Comments Concerning the Proposed Rulemaking to Revise Light-Duty Vehicle Greenhouse Gas Emissions Standards and Corporate Average Fuel Economy Standards: Technical Appendix

Referencing docket ID numbers:

EPA-HQ-OAR-2018-0283

NHTSA-2018-0067

FIGURE 11. Average new light-duty vehicle price to consumers for 2008-2016

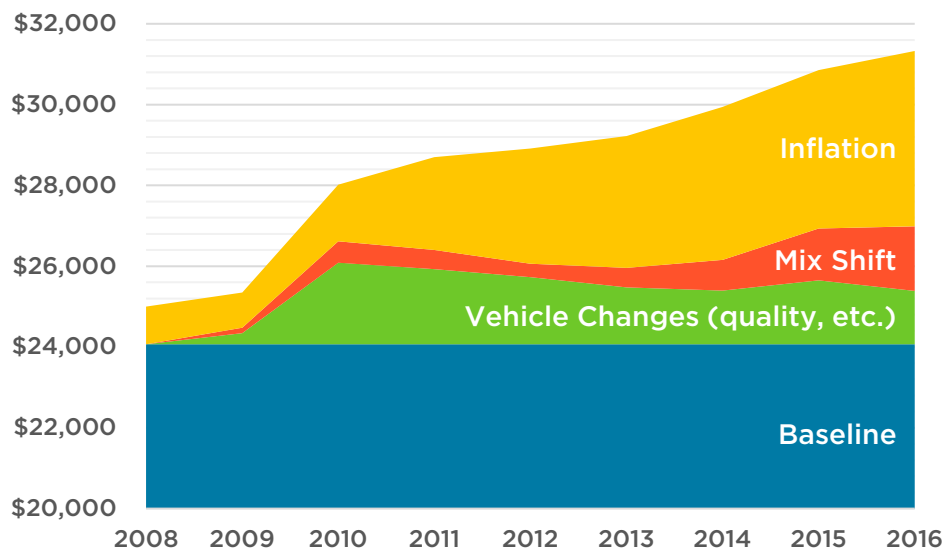
An examination of the factors underlying the recent nominal price increases of the average new vehicle. It is clear from the data that general inflation is the greatest factor, but mix shift plays a greater role than improvements in the vehicle related to compliance with the fuel economy and greenhouse gas standards.

The average new vehicle price to consumers rose from \$25,536 in 2008 to \$31,394 in MY2015 (nominal\$), which equates to a difference of \$2,862 in 2007\$.³⁵ As indicated in Figure 11, nearly half of this difference is directly related to the mix shift, which at \$1,277 (2007\$) is actually larger than the cost of compliance with the regulation assessed in the previous section. This is consistent with previous agency discussion of price increases noting the significant impacts on transaction price from factors such as the mix shift or additional push towards high-end trim packages (Section B.1.6.2, EPA 2016e). This result is further reinforced by analysis from Baum and Associates that showed the rise in high-end trim packages over this time period (Baum and Luria 2016).

FIGURE 12. Job intensity by economic sector

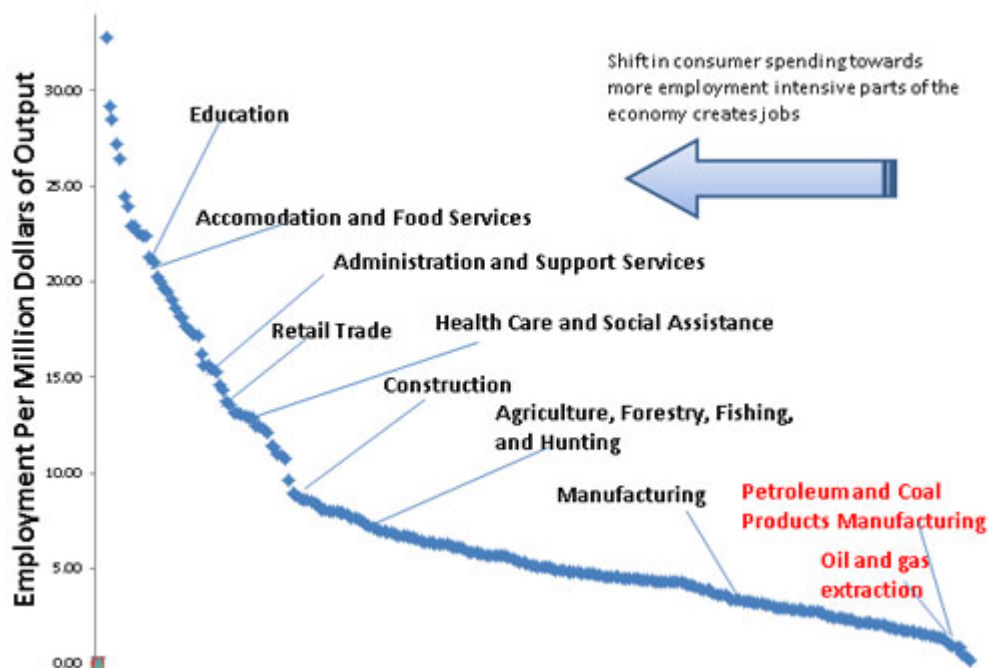
However, there are additional macroeconomic impacts the agencies failed to examine in their analysis including those from changes in spending on gasoline and diesel. Under its Preferred Alternative, Americans will spend an estimated \$20 billion more in 2025 and nearly \$50 billion more in 2035 than under the Baseline Standards (Synapse 2018b). As illustrated in Figure 12, a shift in spending to the petroleum sector from other more job-intensive sectors of the economy results in a net decrease in employment. Economic modeling by Synapse Energy Economics, Inc finds that the net decrease in economy wide employment from the Preferred Alternative would total an estimated 60,000 job-years in 2025 and 126,000 job-years in 2035, significantly more than estimated employment decreases in the auto industry alone by the agencies (Synapse 2018b). Furthermore, reduced investment

Petroleum refining and oil and gas extraction have relatively low employment levels per million dollars of economic output. As a result, a dollar saved on gasoline reinvested in the other sectors of the economy can have a net positive effect on jobs.

FIGURE 13. The uncertain impacts of autonomous vehicles

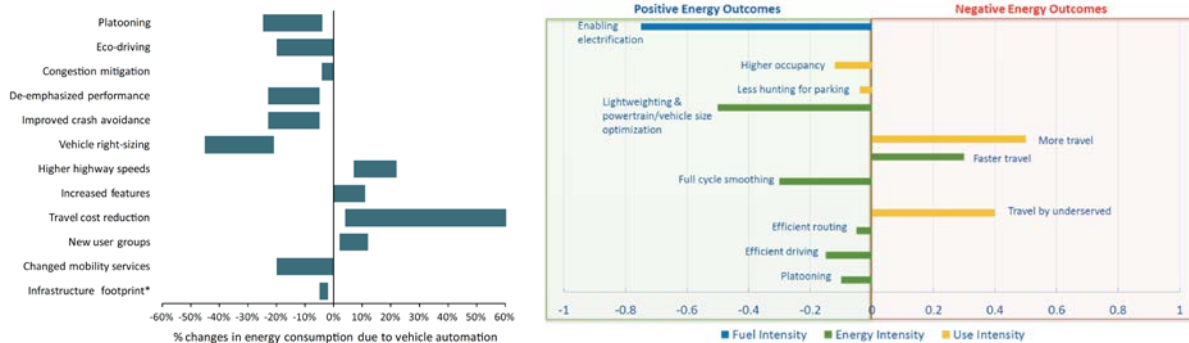
It should be emphasized that while these features **could** improve the efficiency of the transportation system, it is by no mean guaranteed to be the case. This has been explained at length in studies such as Wadud et al. 2016 (Figure 13a) and Brown, Gonder, and Repac 2014 (Figure 13b), which illustrate much of the range of uncertainty around potential (dis)benefits of vehicle automation.

Numerous studies indicate the inherent uncertainty surrounding the impacts on energy and emissions from the adoption of autonomous vehicles. Differences in future technology and use could result in dramatically different possibilities; as such, it would be imprudent to credit such potential technology (dis)benefits with such wildly uncertain outcomes.

FIGURE 14. Annual greenhouse gas emissions benefits under the 2017-2025 standards finalized by EPA compared to those under possible incentive programs

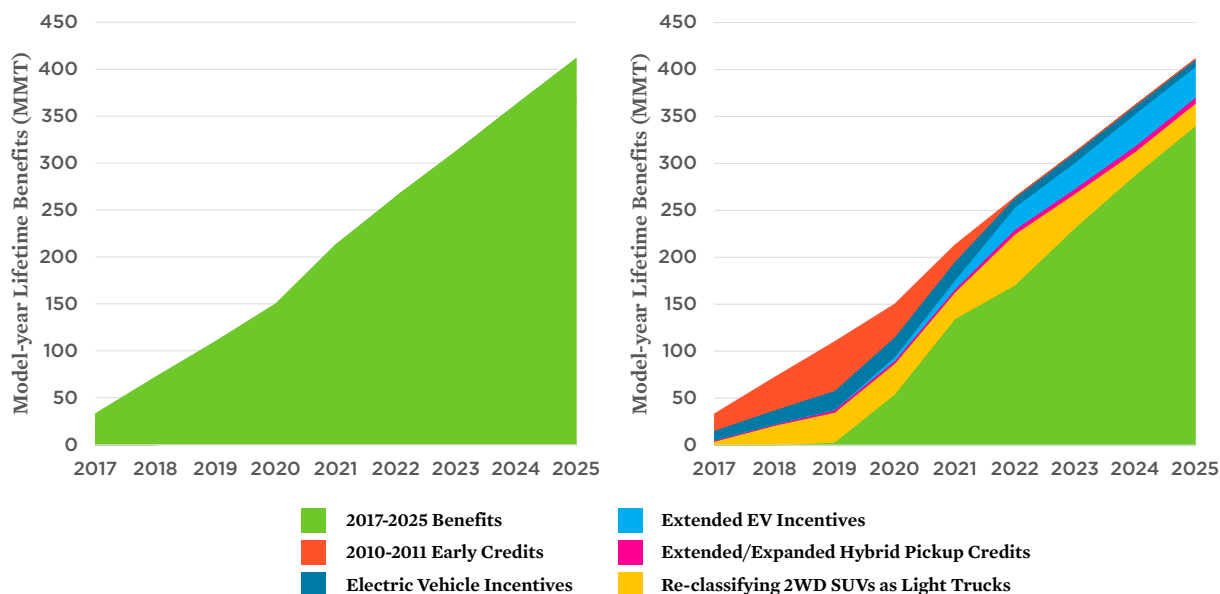
Given the potential interaction for a number of incentives, it is important to consider the potential impact of any such "flexibility" on the overall stringency of the regulation. For example, in Figure **YYY**, we summarize a number of flexibilities either already granted by EPA or requested by automakers (Cooke 2018b). The total impact of these flexibilities in full is nearly equivalent in reduction of greenhouse gas benefits to the freeze proposed by the agencies in its Preferred Alternative—yet on paper, manufacturers under such a scenario would be compliant with MY2025 standards.

Given the potential for widespread harm, credits within the program should be severely limited, and the agencies' assessment of the impacts of such incentives should be extremely conservative in order to best ensure the environmental benefits of the fuel economy and greenhouse gas emissions standards.

While some benefits have already been given away (such as early credits and EV incentives), incentives requested by automakers including extension of multipliers for EVs, exclusion of upstream emissions, expanded credits for hybrid light trucks, and reclassification of 2WD small SUVs would erode the benefits of the 2017-2025 greenhouse gas emissions standards nearly as much as the agencies' current, deeply flawed and harmful proposal.
